## Review of AirCell's September 30, 2004 Paper "Providing Deck-to-Deck Coverage"

Jay Padgett  
Telcordia Technologies  
October 12, 2004

**Figure 1:** The reverse-banding or cross-duplexing concept.

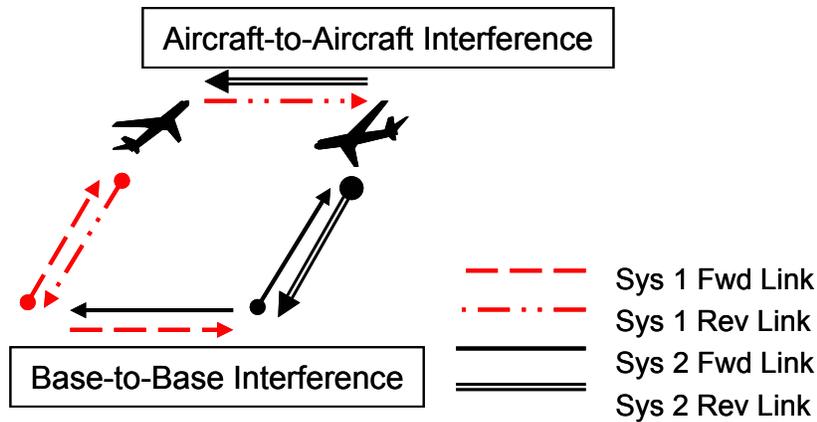
With cross-duplexing, there is the potential for interference between airborne radios of the two different systems, as well as between their base stations. In [2], AirCell presented simulation results that showed the performance degradation due to the air-to-air interference is reduced if the aircraft EIRP is hard-limited to 200 mW. The base-to-base interference problem was ignored in [2]. In [3], Telcordia demonstrated that if the aircraft EIRP was allowed to rise to more reasonable levels, to obtain higher reverse link data rates or to overcome non-idealities in the air-to-ground radio link, the impact of the air-to-air interference on forward link performance could be severe. It was also demonstrated in [3] that in the airport scenario, base stations would be near enough to each other to cause mutual interference (i.e., within the radio horizon).

**Figure 3:** *AirCell's concept for 4-provider sharing using cross-duplexing and cross-polarization.*

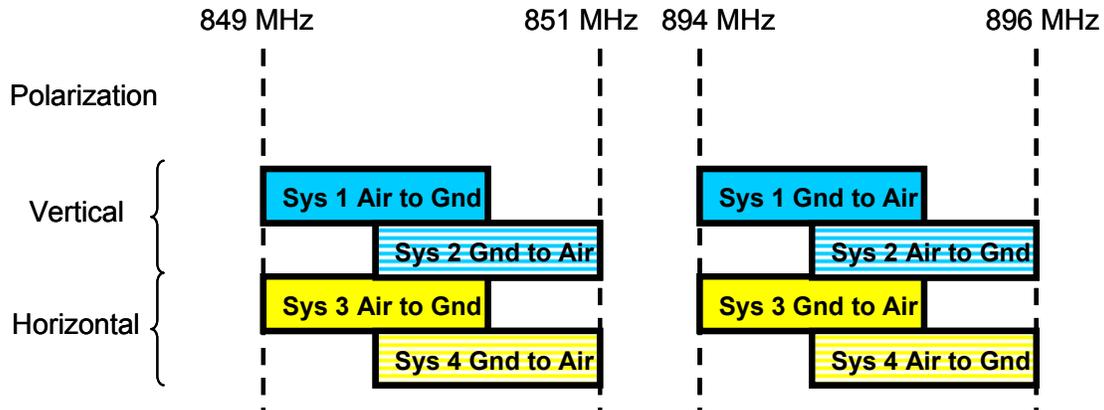
AirCell provided simulation results in [4] for two cross-polarized but co-duplexed operators sharing the spectrum. Those results showed that in the airport scenario, the added interference at the base station receivers would be severe. In fact, the interference levels indicated by AirCell's simulation results were far above the nominal maximum operating point for a CDMA reverse link receiver (6 dB or less above thermal noise). AirCell has yet to explain how it would solve this problem with cross-polarization sharing.

In addition, the prospect for successful sharing using cross-polarization is questionable due to the lack of data on cross-polarization coupling on the air-to-ground propagation path. In [4], AirCell claimed that the results described in [6] supported the use of 12 dB cross-polarization isolation in its simulations. However, as explained in [5], a detailed review of [6] revealed no basis for such a claim. To date, AirCell has not addressed this issue.
